Well Name: CUADRITO AZO FEDERAL	Well Location: T20S / R23E / SEC 31 / NWNW /	County or Parish/State: EDDY / NM
Well Number: 1	Type of Well: CONVENTIONAL GAS WELL	Allottee or Tribe Name:
Lease Number: NMNM94830	Unit or CA Name:	Unit or CA Number:
US Well Number: 300153217200S1	Well Status: Temporarily Abandoned	Operator: EOG RESOURCES INCORPORATED

Notice of Intent

Sundry ID: 2653954

Cuadrito AZO Federal 1
30-015-32172
Lease # NM-94830
865'FNL & 660'FWL
Unit Letter D-31-20S-23E
Eddy County, New Mexico

WELL NAME: Cuadrito AZO Federal #1 FIELD: _____
 LOCATION: 865' FNL & 660' FWL Sec. 31-20S-23E
 GL: ZERO: _____ KB: _____
 COMMENTS: API No.: 30-015-32172

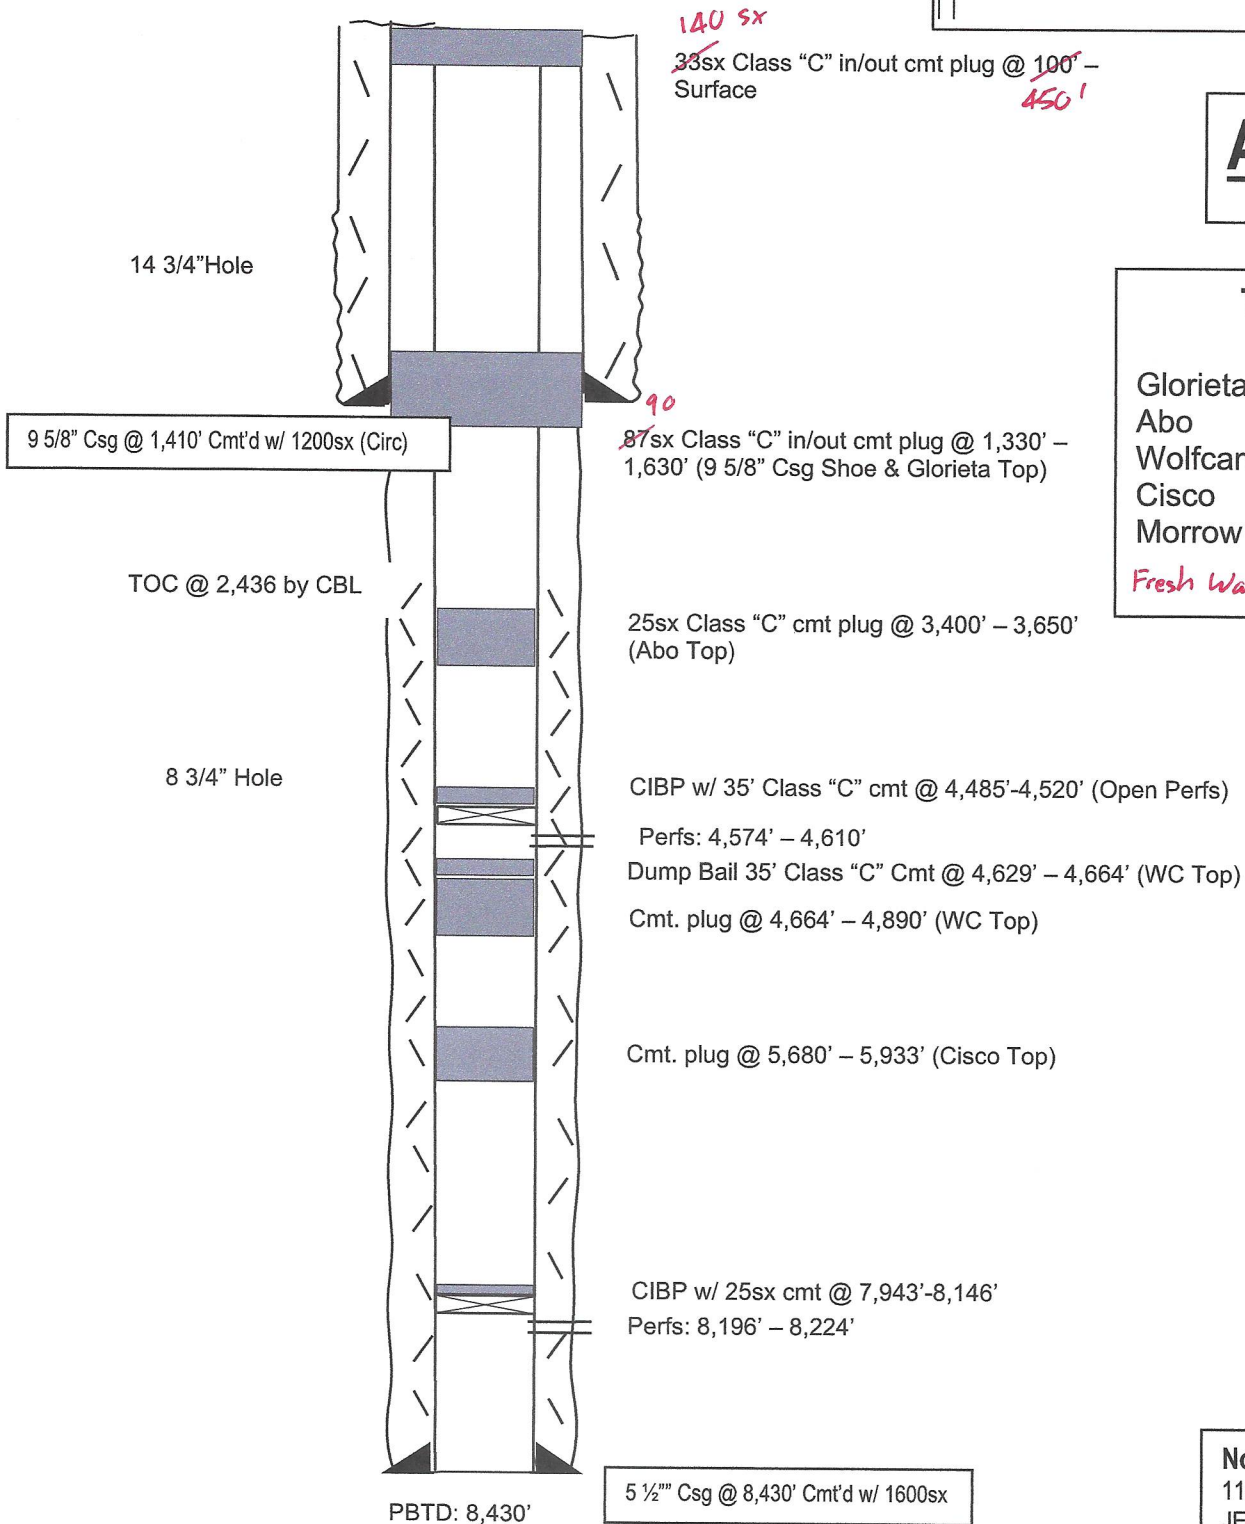
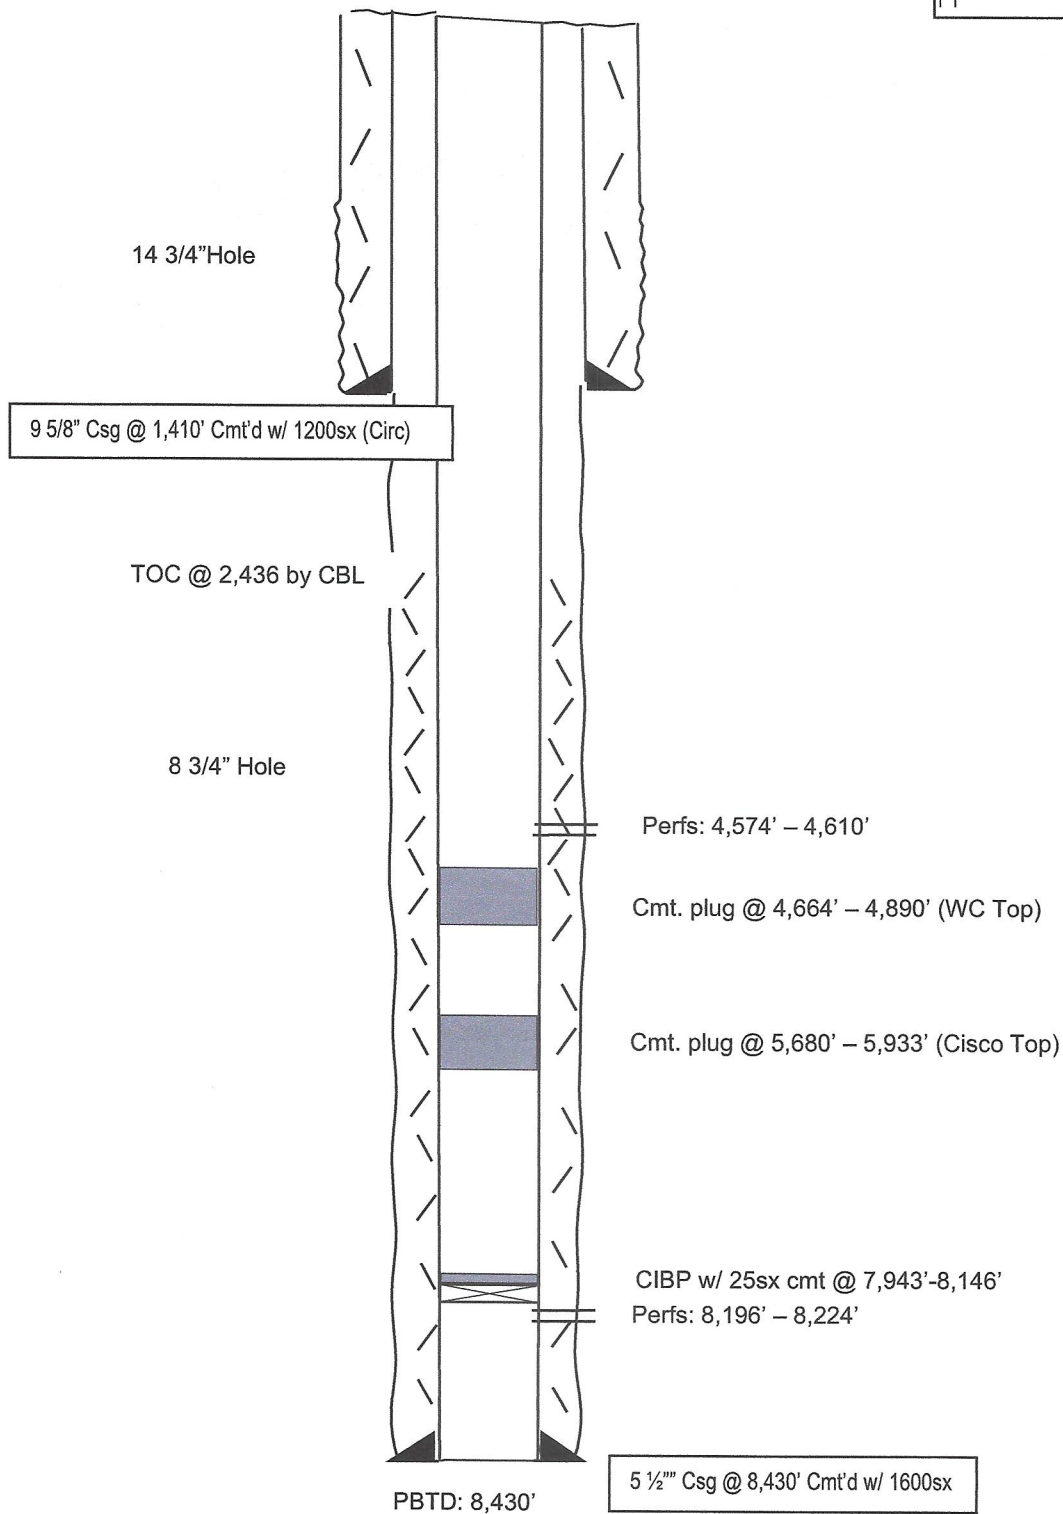
Sundry ID		2653954				
Plug Type	Top	Bottom	Length	Tag	Sacks	Notes
Surface Plug	0.00	450.00	450.00	Tag/Verify		
				If solid base no need to Tag (CIBP present and/or Mechanical Integrity Test), If Perf & Sqz then Tag, Leak Test all CIBP if no Open Perforations		
Fresh Water @ 400	346.00	450.00	104.00		140.00	Perf and Squeeze from 450' to surface. Verify at surface. (In/Out)
Shoe Plug	1360.00	1460.00	100.00	Tag/Verify		
				If solid base no need to Tag (CIBP present and/or Mechanical Integrity Test), If Perf & Sqz then Tag, Leak Test all CIBP if no Open Perforations		
Glorieta @ 1578	1512.22	1628.00	115.78		90.00	Perf and Squeeze from 1630' to 1330'. WOC and Tag (In/Out)

If solid base no need to Tag (CIBP present and/or Mechanical Integrity Test), If Perf & Sqz then Tag, Leak Test all CIBP if no Open Perforations		
ABO in Plateform Shelf @ 3598	3512.02	3648.00	135.98		25.00	Spot from 3650' to 3400'.
				If solid base no need to Tag (CIBP present and/or Mechanical Integrity Test), If Perf & Sqz then Tag, Leak Test all CIBP if no Open Perforations		
CIBP Plug	4485.00	4520.00	35.00		5.00	Leak Test CIBP. Dump Bail 35'.
Perforations Plug (If No CIBP)	4524.00	4660.00	136.00	Tag/Verify		Not Necessary

If solid base no need to Tag (CIBP present and/or Mechanical Integrity Test), If Perf & Sqz then Tag, Leak Test all CIBP if no Open Perforations		
Wolfcamp @ 4692	4595.08	4742.00	146.92		5.00	Dump Bail from 4664' to 4629' on top cement plug. WOC and Tag.
Shoe Plug	8380.00	8480.00	100.00	Tag/Verify		Not Necessary

No more than 2000' is to be allowed between plugs in open hole, and no more than 3000' between plugs in cased hole.
Class H >7500'
Class C <7500'
Fluid used to mix the cement in R111P shall be saturated with the salts common to the section penetrated, and in suitable proportions, but not more than 3% calcium chloride by weight of cement will be considered the desired mixture whenever possible.
Critical, High, Medium, Secretary : Top of salt to surface If no salt take the deepest fresh water.
R111P: 50' from bottom of salt to surface
